# Mount Street 100 North Sydney

Preferred Project Report

December 2009

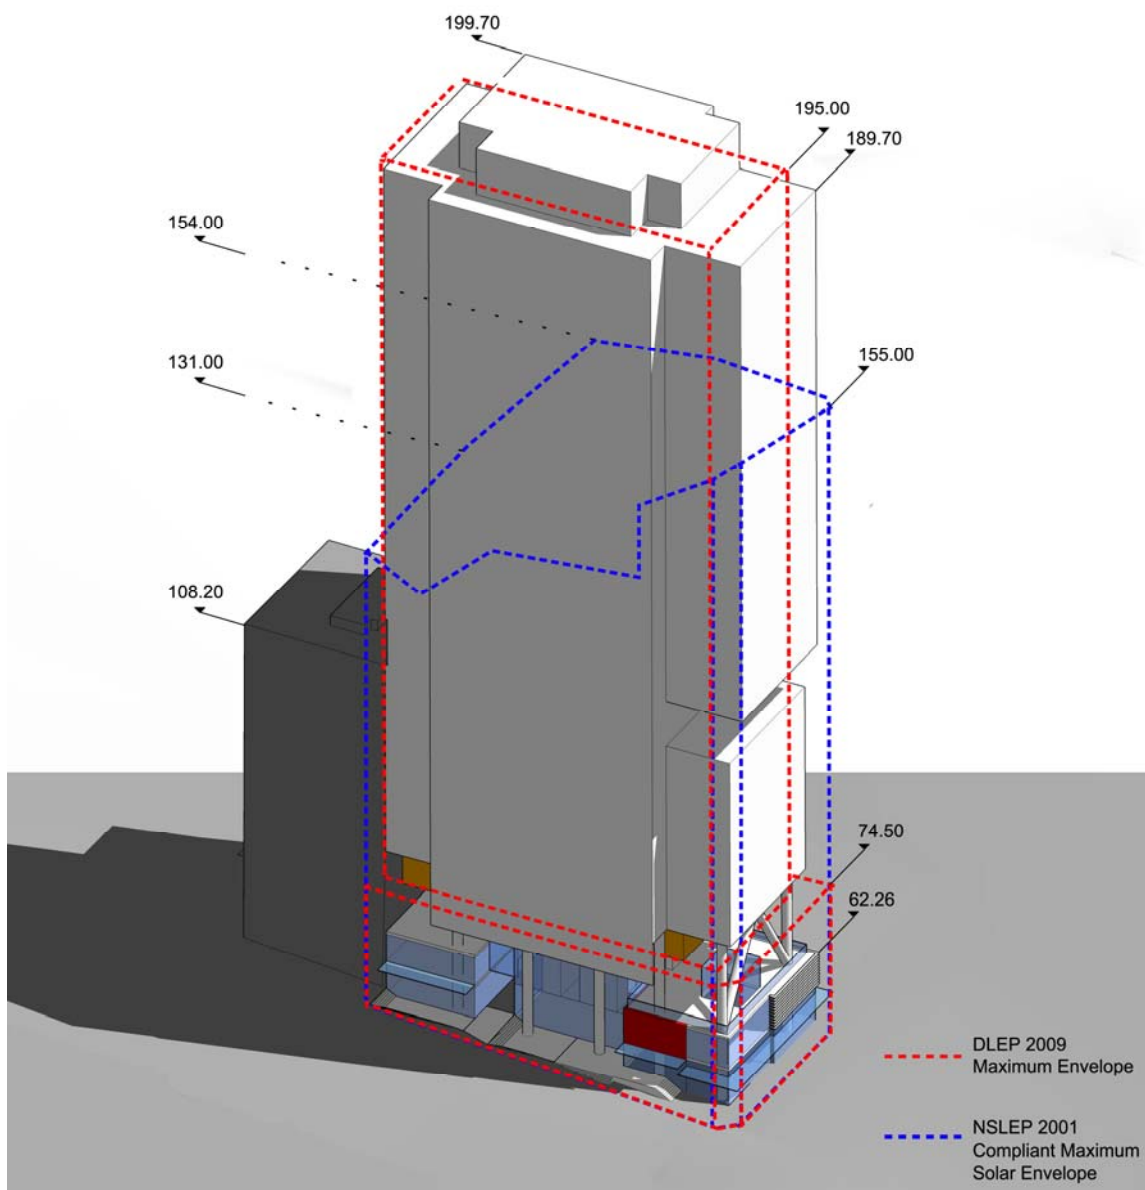
The existing overall height standard under LEP 2001 is RL 195 AHD. An amended reverse engineering exercise of overshadowing impact reveals that the actual maximum envelope achievable reaches up to RL of 155m and therefore the extent of variation is at least 45m at the northern property boundary.

The proposal extends up to RL 199.7 AHD and the non-compliance against the draft standard is 4.7m (above the RL 195 AHD).

But for the onerous overshadowing standard, the existing LEP 2001 and proposed LEP 2009 building envelope would be the same. Removal of the onerous overshadowing standard now allows the full potential of the existing LEP envelope to be achieved.

A graphic illustration of the maximum envelope under both the existing and draft LEP is included below.

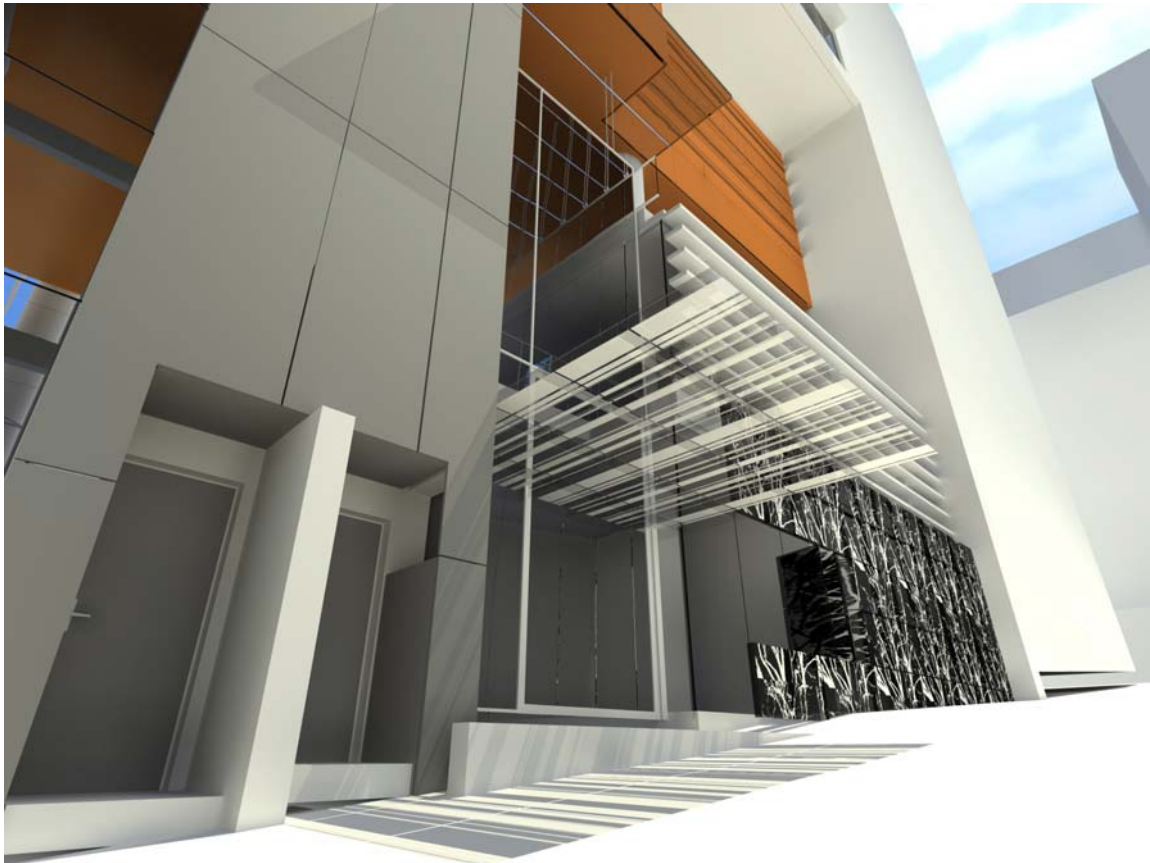
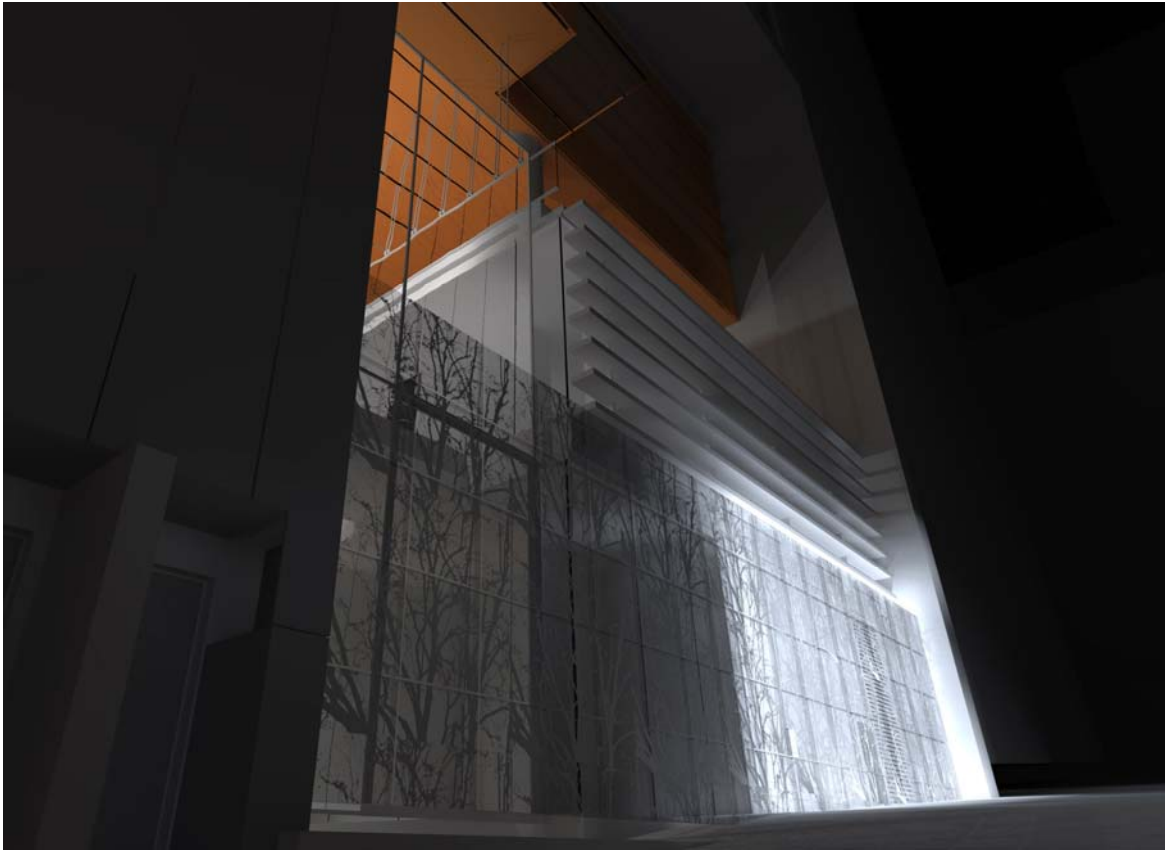
The Mount Street setback has been further resolved to ensure the levels better align with the existing Mount Street footpath. As illustrated in the attached plan by Oculus, a series of steps have been incorporated to minimise the need for retaining walls and balustrades. The area still allows for the location of outdoor seating to activate the street and will now allow pedestrians continuous passage undercover parallel to Mount Street and within the site property boundary – a genuine expansion to the width of Mount Street.

A through-site link has been incorporated. The size of the through-site link has been maximised to provide a safe and attractive passage for pedestrians. In addition, the link is lined with retail space to ensure activation.

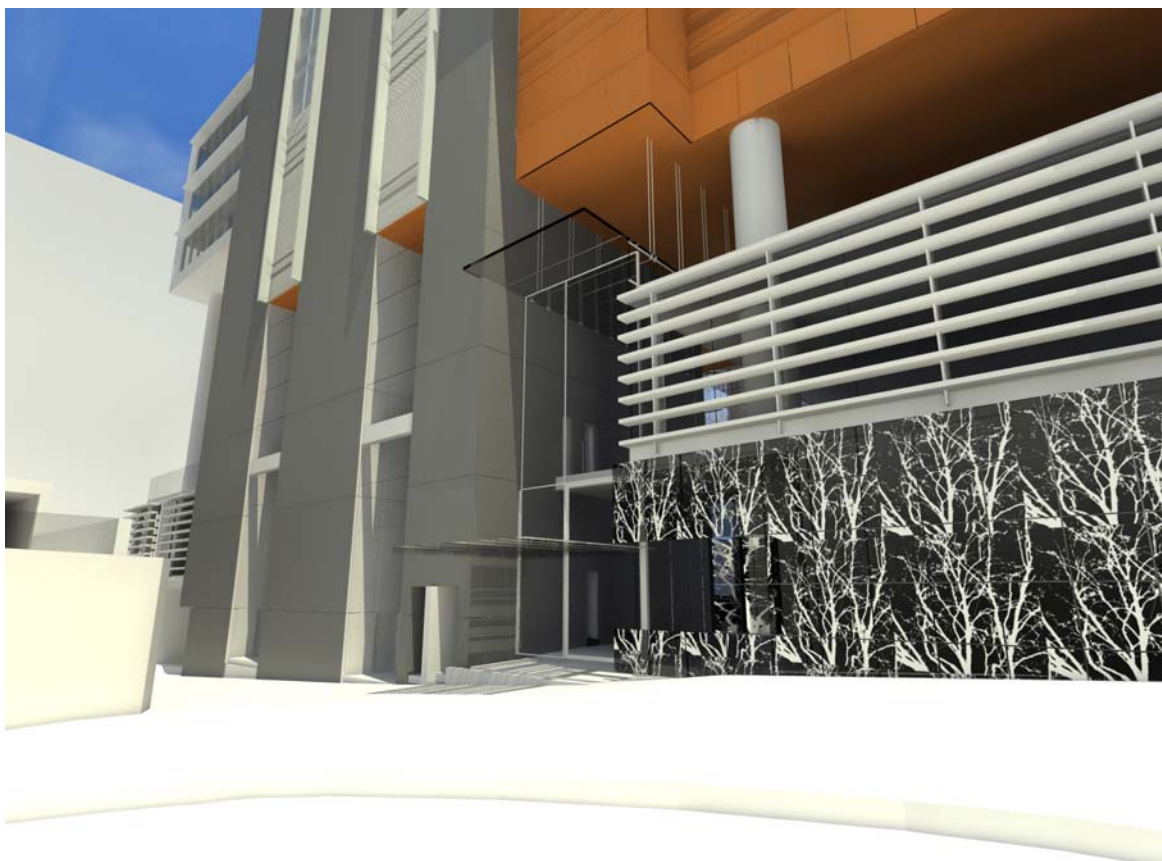
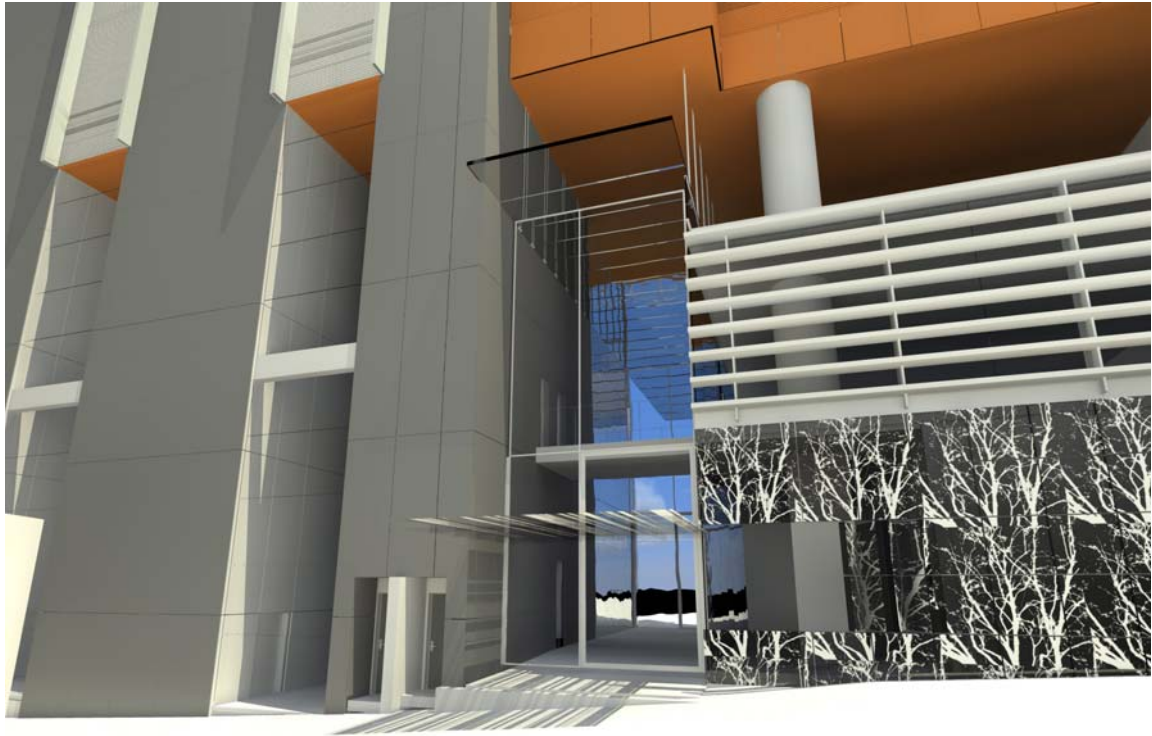
Extensive design options analyses were undertaken in an attempt to improve the relationship of the proposal with the adjoining No.88 Walker Street development and its associated public space to the north. Deletion of the service vehicle entry fronting the space was explored and is not considered possible due to issues of clearance, swept path at entry/exit, ramp gradients and impact upon the retail space fronting Mount Street. As a result, it was not possible to amalgamate the service entry with the car park entry. The best alternative involves the reduction of the service entry to single width. In

addition, incorporation of a turn table at basement level will allow forward entry and exit of trucks and eliminate any manoeuvring of trucks on Spring Street. This improvement comes at great expense but brings with it significant improvements within Spring Street. A storyboard of the design exercise is included in **Section 4.1.2** below

Improvements to the Spring Street interface are illustrated in the images below.

Photomontage - Corner of Mount and Walker Streets, Close Up

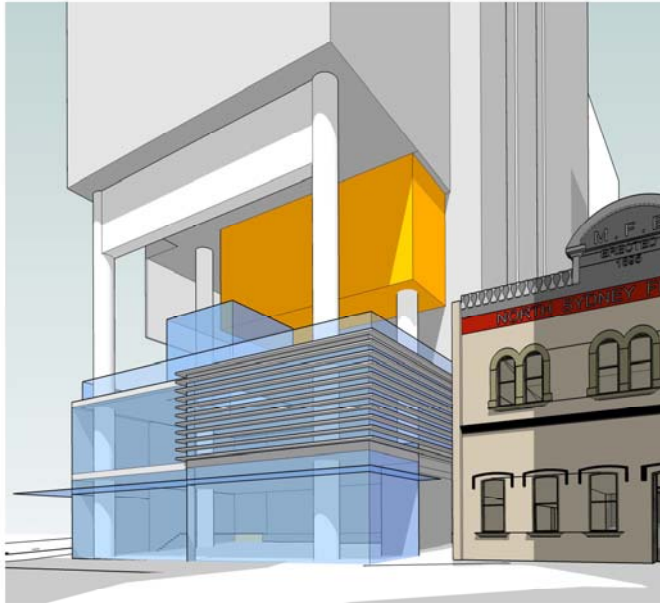
The finished ground level within the Mount Street setback has been amended and all obstacles like retaining walls and services have been removed. Pedestrians can now walk uninterrupted under cover within the site parallel to Mount Street. The changes also make way for the removal of the existing retaining wall on the adjoining site at 80 Mount Street and allow for the widening of public space for the length of the entire block.

The improvements to the Mount Street setback are illustrated in the plans by Oculus at **Appendix C** and the photomontage below.

Photomontage - Corner of Walker and Spring Street

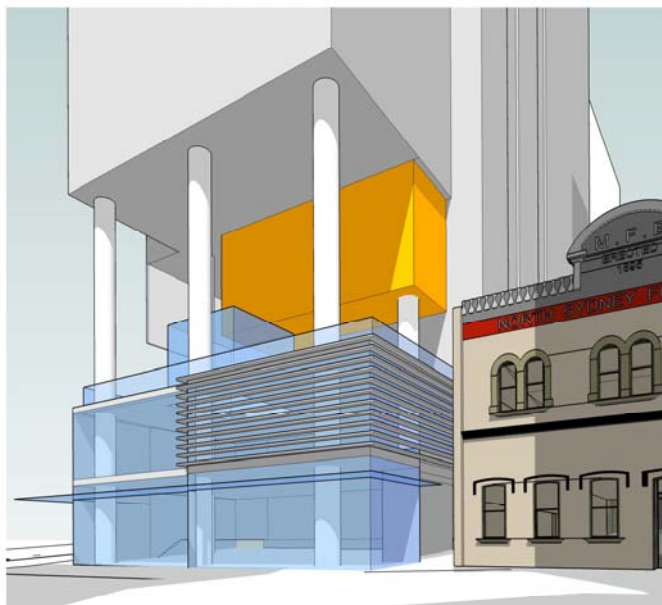
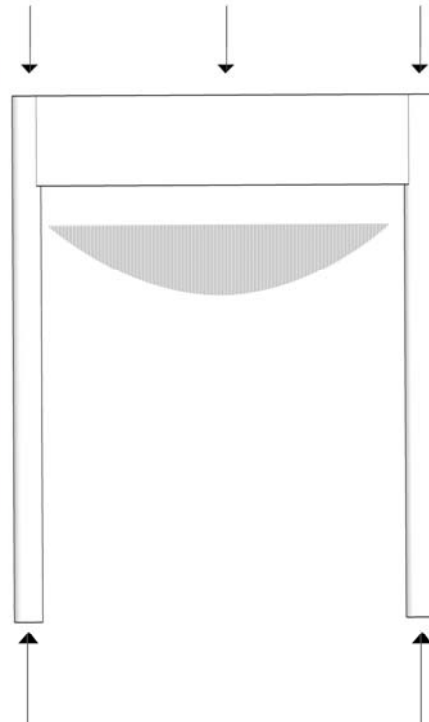
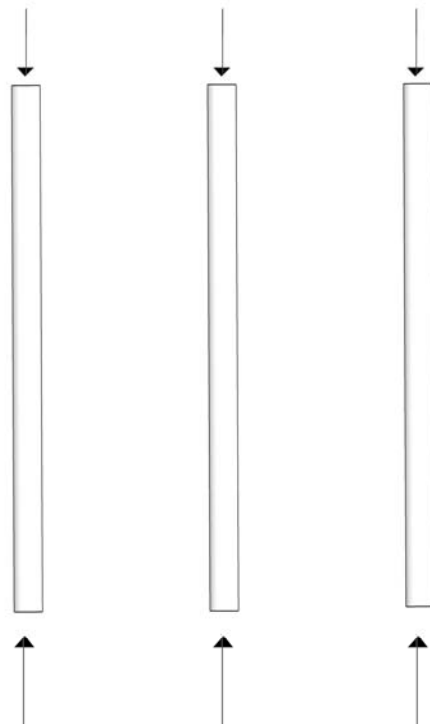
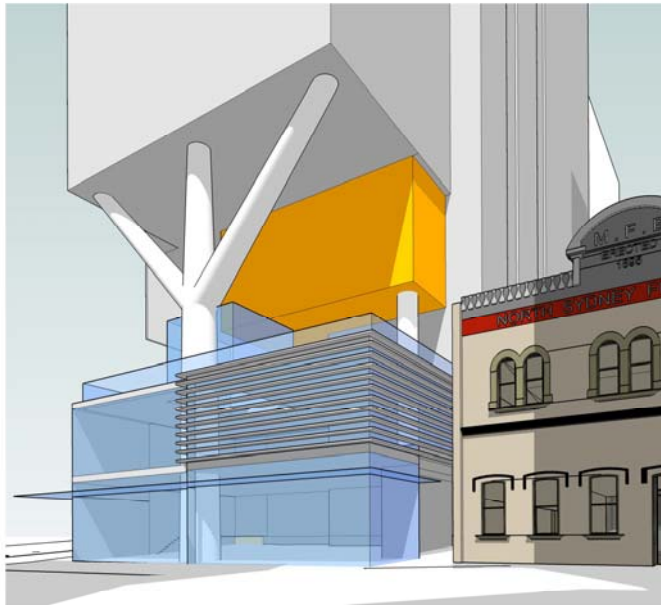
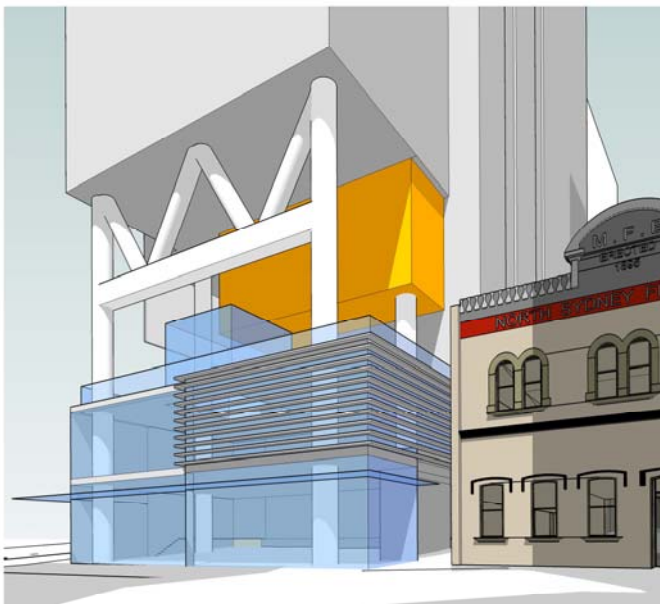
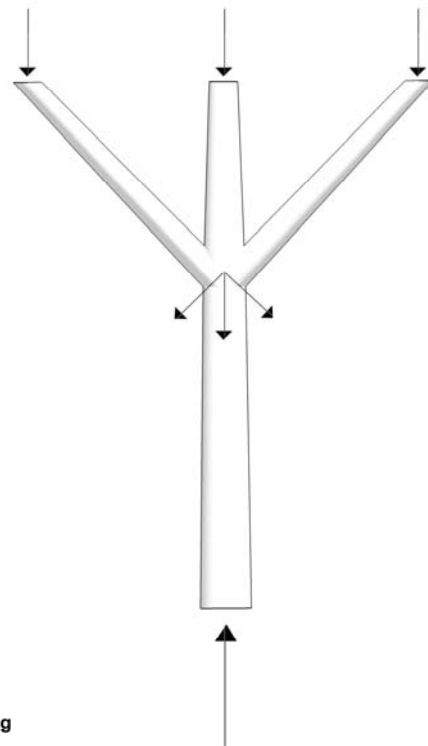
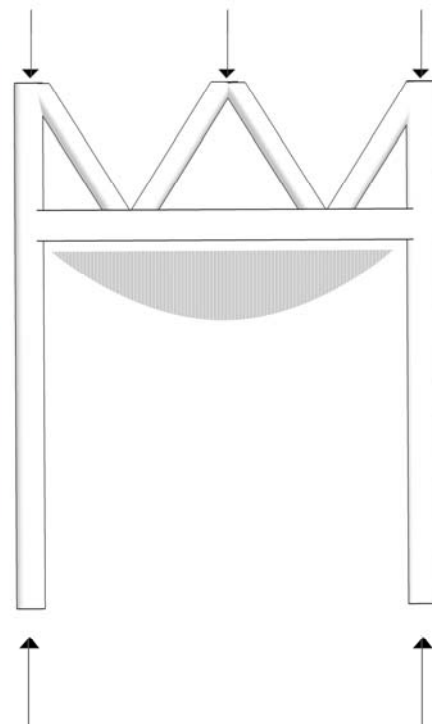
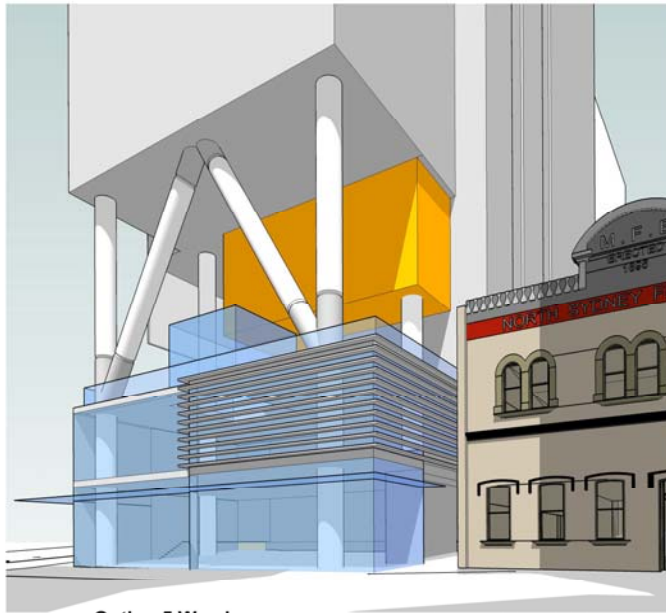
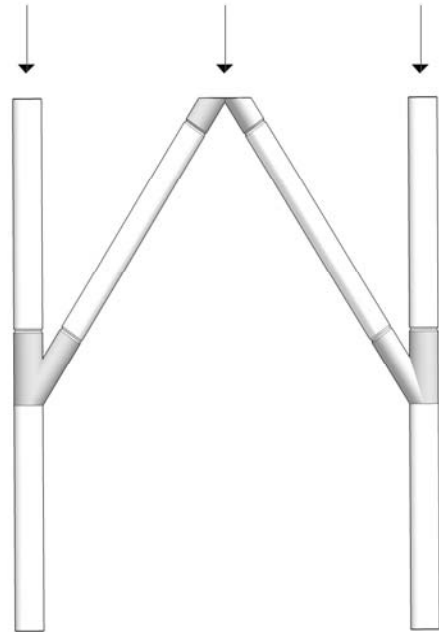
The proposed design resolution between levels 8 and 12 was revisited. As outlined in the attached architectural design statement at **Appendix D**, the 'reverse podium' design has been chosen to project a strong architectural message and create a building with identity befitting its central CBD location.

The form and resolution of the exposed structural frame was also revisited and found to be a superior option, refer to design analysis below. The materials and finishes of the structure are further discussed in the attached architectural design statement.

**Spreads the structural load efficiently to the two outer columns  
draws the eye up**

**Allows the podium to divide into two elements**

**Maximises open space and thus light penetration.**
